APPENDIX E

Public Information Centre No. 2

CLASS ENVIRONMENTAL ASSESSMENT STUDY

Guelph Line (Regional Road 1) Transportation Corridor Improvements
1 Kilometre North of Derry Road (Regional Road 7) to Conservation Road,
Town of Milton
PR-2596A

**Guelph Line (Regional Road 1)
Typical Rural Roadway Cross-Section**

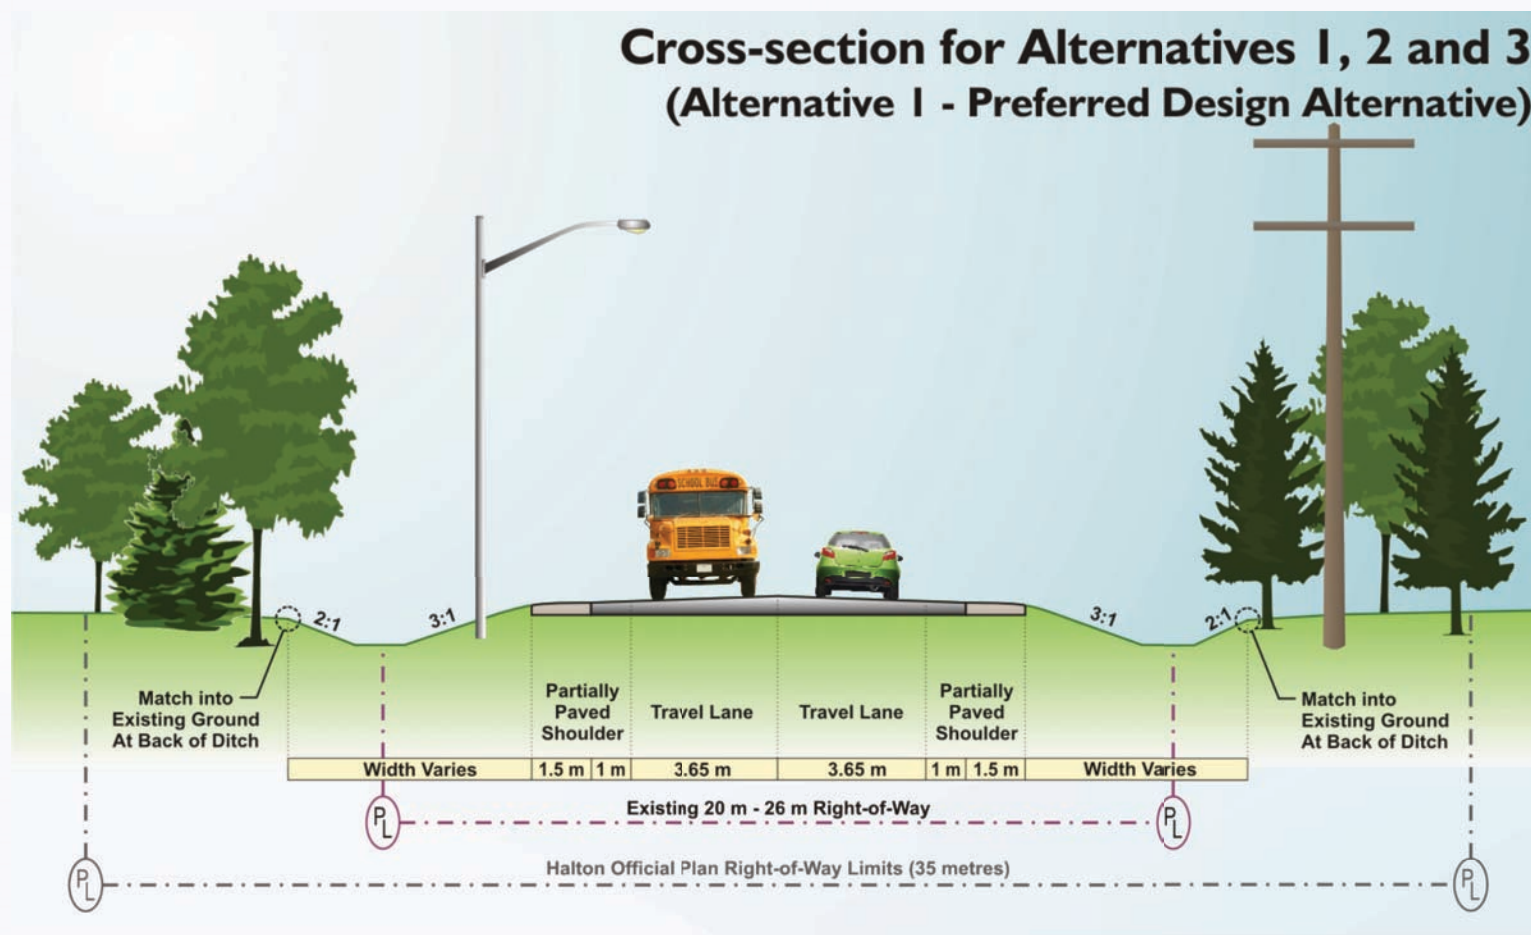
No.	Description
	Plan, it is anticipated that traffic will grow by approximately three percent per year.
e.	<p>Concern: <i>The Preferred Alternative shows the southern portion of the roadway designed with ditches, while the northern section is designed with curb and gutter and storm sewers. A concern was raised over the curb and gutter section from a safety perspective.</i></p> <p>Follow-up Comments: There was discussion on the benefits of extending the ditches through the entire project area even though it would require additional property from Conservation Halton. The benefit of this would be a larger buffer zone along each side of the roadway. This would require the need to remove larger areas of rock outcrops and additional impacts to Conservation Halton lands. The intent of the urban cross section was to reduce the road platform width, thereby reducing the potential impacts to Conservation Halton lands, controlling stormwater drainage (i.e. containing stormwater within the roadway and not allowing it to flow directly onto the adjacent lands), and reducing the need to remove additional rock. In addition, the urban cross-section would minimize impacts to existing utilities (e.g., gas main and hydro facilities) while still providing a 1.0 metre shoulder for cyclists and pedestrians (an improvement over current existing conditions).</p>

Preferred Design Alternative Roadway Improvements

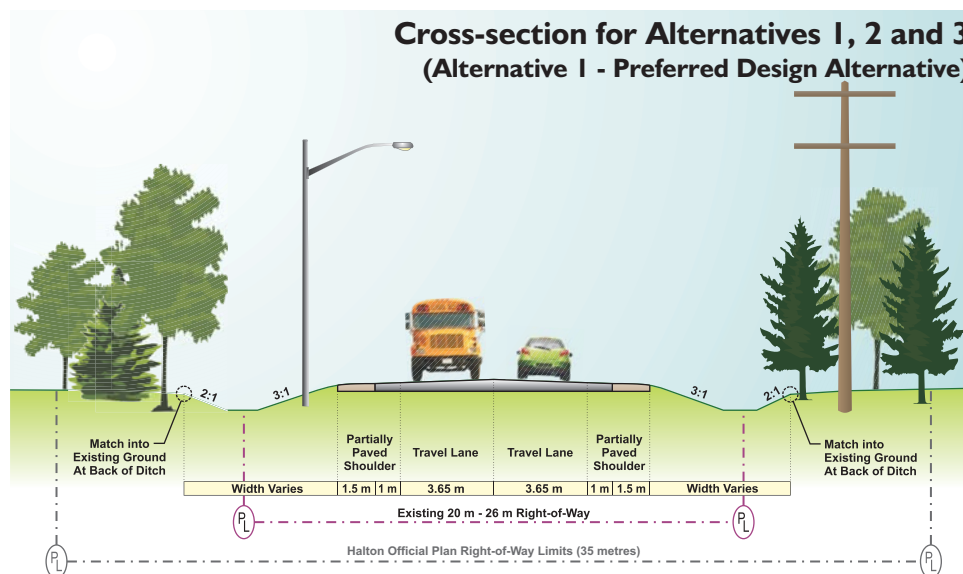
f.	<p>Concern: <i>Will widening the curves at the S-bend require additional land?</i></p> <p>Follow-up Comments: Widening the existing 140 metre radius curve to a proposed 250 metre radius curve will require approximately 0.10 hectare of property. Exact property requirements will be determined at the detail design stage.</p>
